Comments on Sections 3.3.2 and 3.3.3 of

**"Elements of Proof to Demonstrate Substantially Complete Containment
of HLW Within the Waste Package,"**

CNWRA-89-xxx, November 25, 1989

**R. E. Ricker
December 11, 1989**

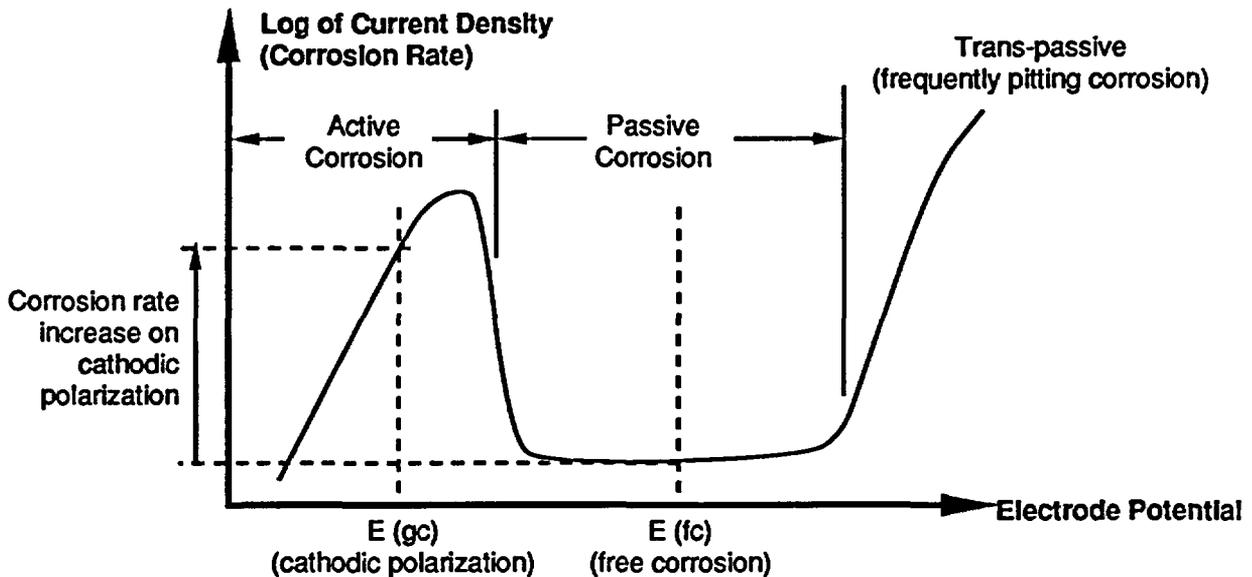
3. This section sounds like one of our point papers on the SCP or the CDSCP.
4. Ni, Fe, Cr alloys
5. It may not be desirable for the canister to be cathodic with respect to other components. I say this for two reasons:
 - a. Hydrogen embrittlement: If the container material is susceptible to hydrogen embrittlement, then cathodic polarization will promote hydrogen absorption and embrittlement.
 - b. Passive to Active transition: Some of the materials being considered for the container resist corrosion by forming a thin protective or passivating film. The maintenance of this film requires that the potential of the surface remain in the range when the film is stable. Cathodically polarizing the material may cause a breakdown of the film and an increase in the dissolution rate as illustrated in the figure below.
